Terex Utilities**PRODUCT NOTICE****PN691****DATE:** 7/27/2021**REVISED:****TO:** Owners, Users, Dealers, and Installers**MODELS AFFECTED:** TL17i Swing Arm Aerial Devices**SUBJECT:** Rotator Bracket Weld Crack**Issue:**

Figure 1. Area of machine to inspect (2 places)

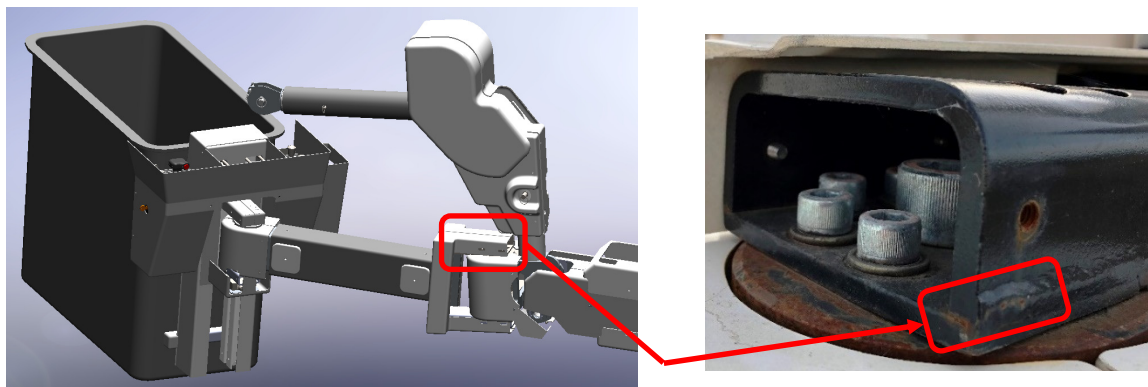
Terex TL17i Swing Arm aerial devices, produced from January 2013 to December 2018, may have deficient welds on the rotator bracket. These welds may fatigue and crack. **Failure of the rotator bracket welds may result in the swing arm and basket sagging out of level.**

1. Inform all users, operators, and supervisors that the rotator bracket must be inspected within 30 days of receipt of this bulletin.
2. Inspect the unit to determine if your unit has cracking of the rotator bracket welds using the figures below as reference. The area to inspect is directly over the hydraulic rotator at the end of the telescopic boom. Covers will need to be removed to inspect the rotator bracket.

3. If your unit has cracking of the rotator bracket welds, do not continue to use the unit until repaired. Contact your local dealer to arrange for repair.
4. If your unit does not have cracking of the rotator bracket weld, follow the Continued Use Instructions in this bulletin. Always follow operation, inspection, and maintenance requirements as specified in the manuals.

Terex will provide a replacement rotator bracket at no cost to the customer, 8 hours for labor to remove the existing bracket and install the replacement bracket, and up to 4 hours for travel to the machine.
